Product: Cluster	Description Horn Capacitor Marine Cluster IO and OB	Date Jan 08
Type: Electrical		Issue 1

VDO Marine Customer Service Bulletin

Product Line: All Marine Clusters, I/O and OB **Date:** 6.3.99

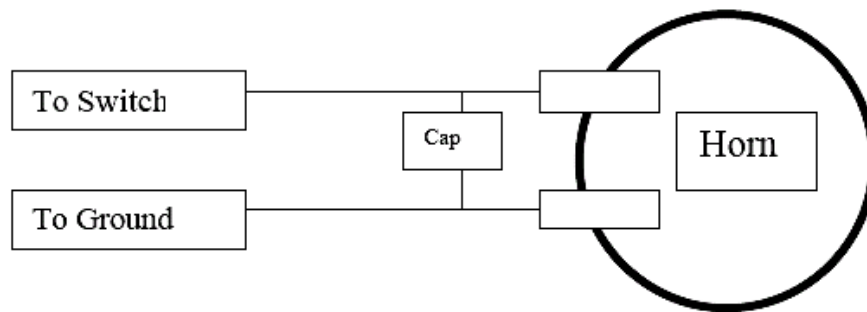
Problem: Using the signal horn will sometimes cause the Cluster to reset (Turn off and then On).

The boat Horn when used will cause a momentary voltage drop that may exceed the cluster 7 volt working threshold causing the cluster to shut off to protect the processor. The cluster will automatically reset when the horn button is released however the depth and clock settings will reset to the default of “No depth alarm” and “12:00”

Field Solution: Installing a 50v, 10 μ f, non polarized Capacitor between the two Horn contacts will eliminate this problem.

A permanent corrective action has been taken to see that all future wire harnesses will be built with this unit installed.
